**SB-GA8-2012-85**

# Service Bulletin

Modifications required for aircraft to be registered in Malaysia

**Figure 1 :** Screws to be removed to gain access to internal assembly of the solenoid box

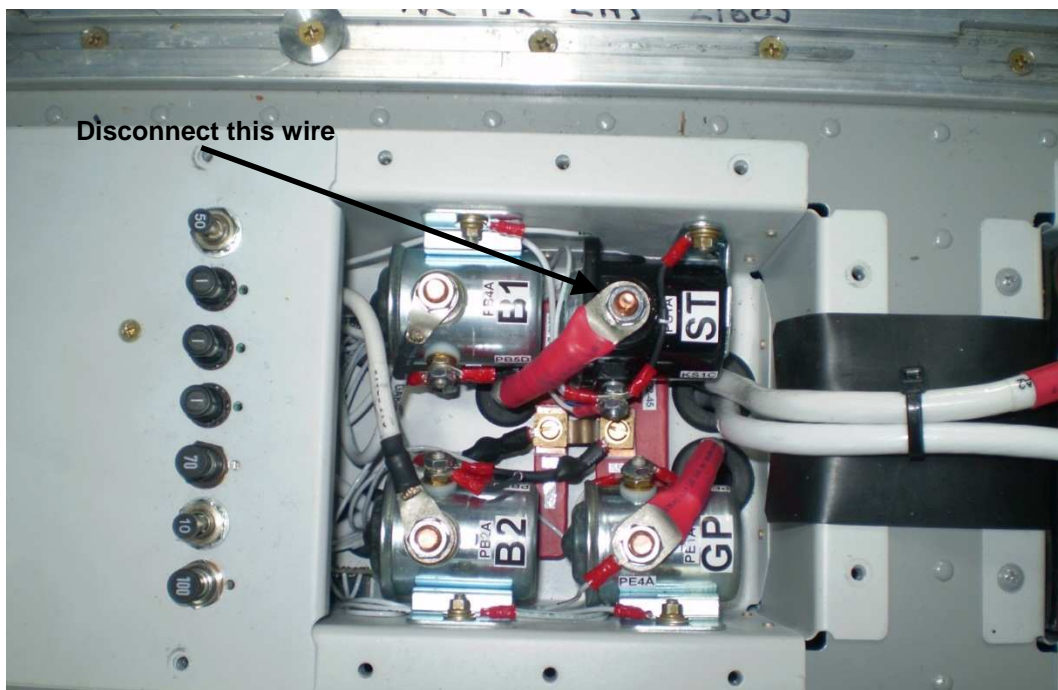
3. Gain access to the internal components of solenoid box by removal of screws as noted in Figure 1. Take care not to damage the heads of the screws when undoing them. Remove the fibre glass sheet. Refer to the GA8 Service Manual Section Chapter 24 taking specific note of the warning in Section 24-00-00.

**Figure 2 :** Location of circuit PS1A2

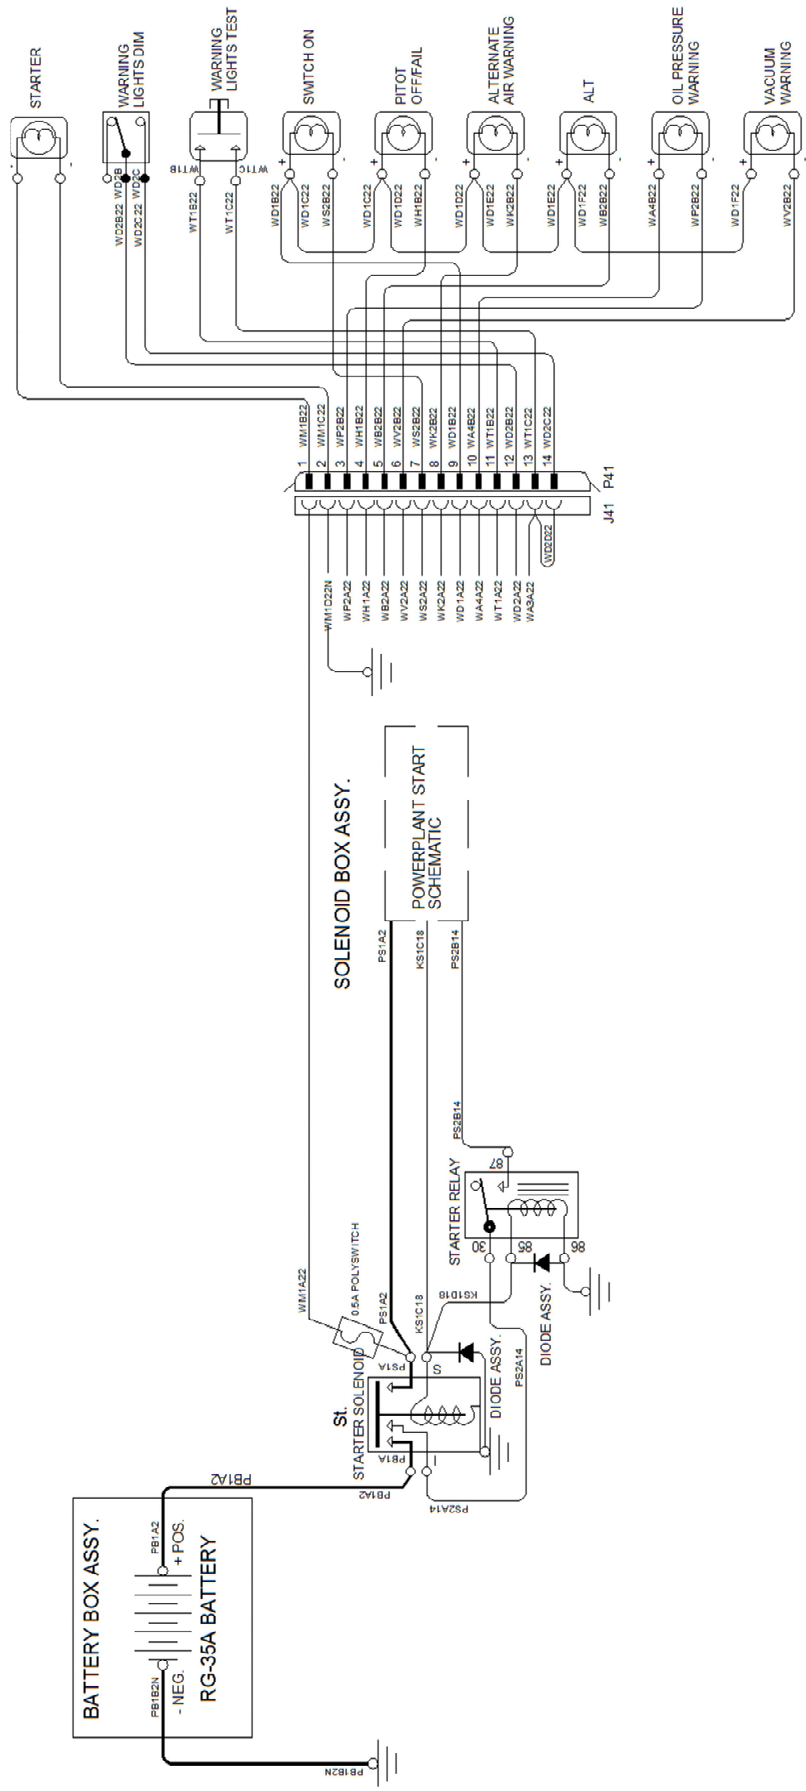
4. Disconnect circuit PS1A2 from the Starter Solenoid. Refer to Figure 2.
5. Fabricate a single wire assembly, circuit WM1A22 as shown in Figure 3.
6. Combine the ring terminals associated with circuits PS1A2 and WM1A22 back onto the solenoid electrical terminal.

Figure 3 : Partial wiring schematic

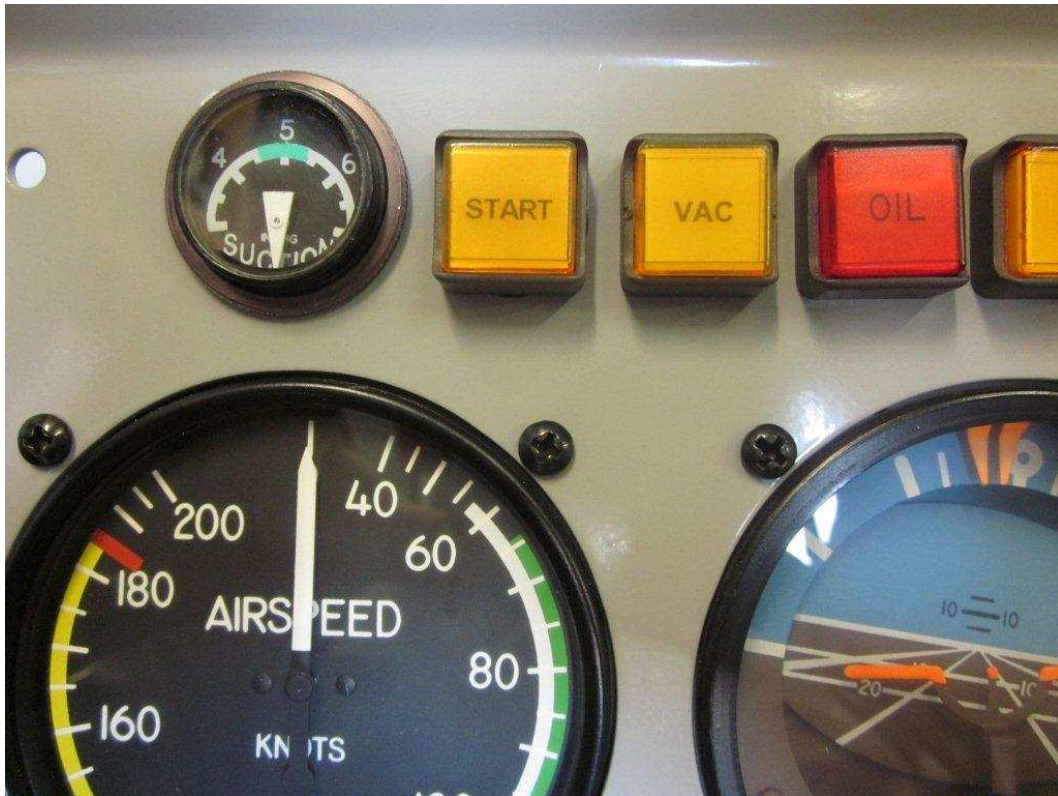
12. Modify the "warning light" loom by inserting circuits WM1B22 and WM1C22 as shown in Figure 3.
13. Re-install the instruments (i.e. ASI, altimeter), loom, and annunciator into the new instrument panel. Figure 4 shows the flight instrument panel fitted with the START annunciator.
